10/572,651

Office Action Summary	Application No. 10/572,651	Applicant(s) CUNNINGHAM, AARON CHRISTIAN	
	Examiner TRAVIS RUBY	Art Unit 3744

DETAILED ACTION

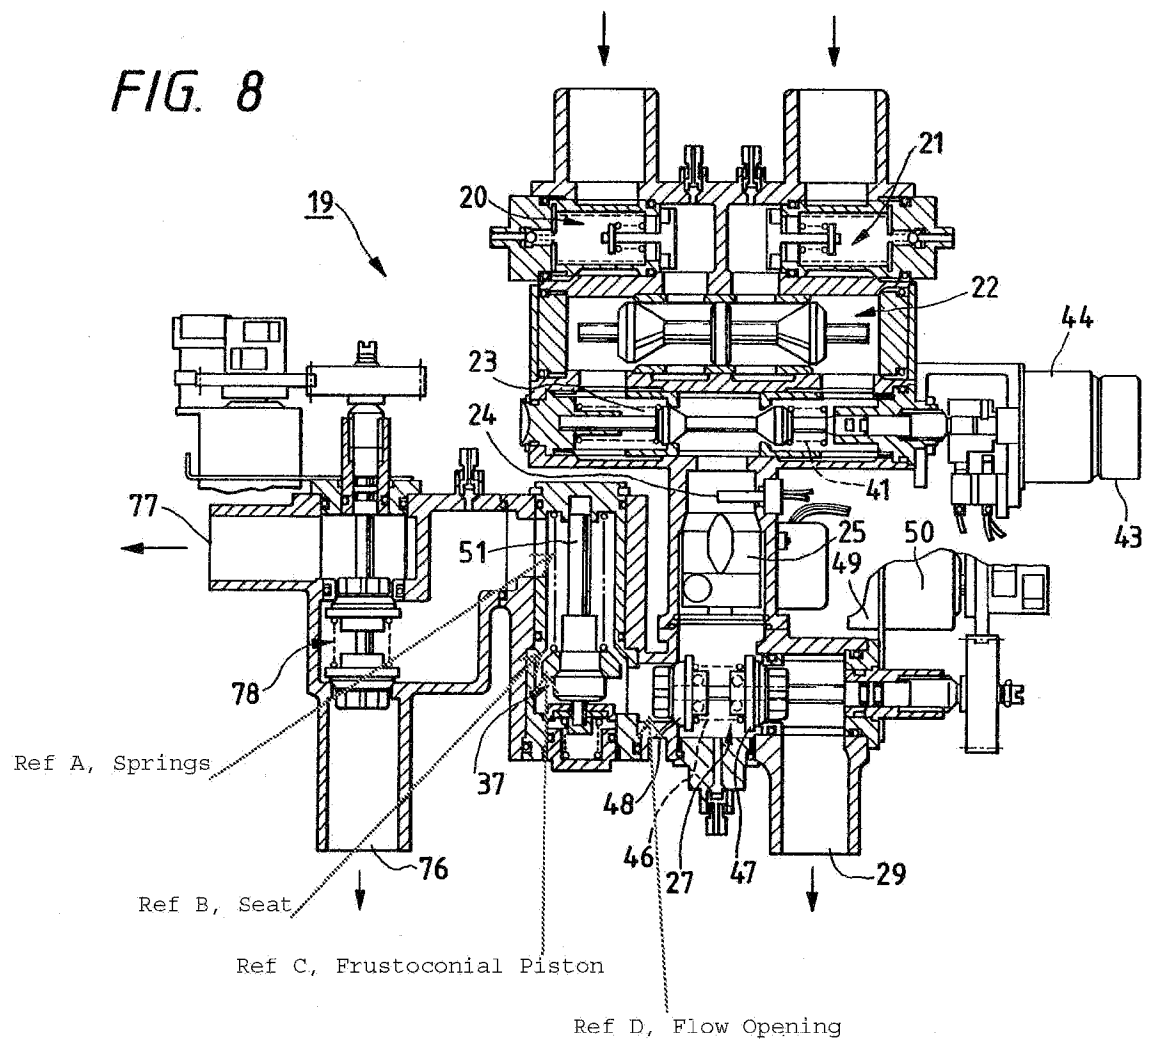
Re Claim 5. A liquid mixing valve according to claim 1, said shut off device (ref 51) including a piston which is positioned in proximity of an opening of said flow passage, for movement toward and away from said opening (Figure 8 below illustrates that the shutoff device is attached to a piston that is activated by the thermostatic element, said shutoff device being located near the inlet ,ref D, to the safety valve, Column 3 lines 35-38, Column 4 lines 23-36).

Re Claim 6. A liquid mixing valve according to claim 5, said piston being arranged to closely approach said opening (ref D in Figure 8 above) (Figure 8 illustrates that the valve 52 is close to the opening, Column 4 lines 23-36).

Re Claim 8. A liquid mixing valve according to claim 5, wherein said piston is generally cylindrical and includes a conical or frustoconical axial end portion in facing relationship with said opening (Figure 8 above ref C illustrates that the piston has a conical end in relationship with the opening).

Re Claim 11. A liquid mixing valve according to claim 1, said shut off device including a piston which is positioned in proximity to an opening formed in said flow passage, said piston being arranged for movement across said opening to restrict flow of water through said opening (Figure 8 above refs B and C illustrates that the shutoff device is attached to a piston that is activated by the thermostatic element, said shutoff device being located near the inlet to the safety valve, Column 3 lines 35-38, Column 4 lines 23-36).

Re Claim 13. A liquid mixing valve according to claim 1, wherein said shut off device includes a piston and biasing means to bias said piston to a position allowing generally unrestricted flow of liquid through said safety valve (Figure 8 above illustrates that the shutoff device is attached to a piston that is activated by the thermostatic element, said piston is biased by a spring, ref A in the illustration, the two long lines on each side of the ref 51 are indicative of springs, Column 3 lines 35-38, Column 4 lines 23-36).

Re Claim 16. A liquid mixing valve according to claim 15, said biasing means being a coil spring mounted in compression to act on said piston (Figure 8 above illustrates that the shutoff device is attached to a piston that is activated by the thermostatic element, said piston is biased by a spring, ref A in the illustration, the two long lines on each side of the ref 51 are indicative of springs, Column 3 lines 35-38, Column 4 lines 23-36).

Re Claim 18. A liquid mixing valve according to claim 17, said engagement being fixed engagement (Figure 8 above illustrates that the piston and plunger are in contact with each other, Column 3 lines 23-36).

Re Claim 19. A liquid mixing valve according to claim 17, said engagement being abutting engagement (Figure 8 above illustrates that the piston and plunger are in contact with each other, Column 3 lines 23-36).

Re Claim 20. A liquid mixing valve according to claim 17, said casing being fixed against movement within said flow passage (Figure 8 above illustrates that the piston is biased by a spring, ref A in the illustration, the two long lines on each side of the ref 51 are indicative of springs which would prevent the casing from movement, Column 3 lines 35-38, Column 4 lines 23-36).
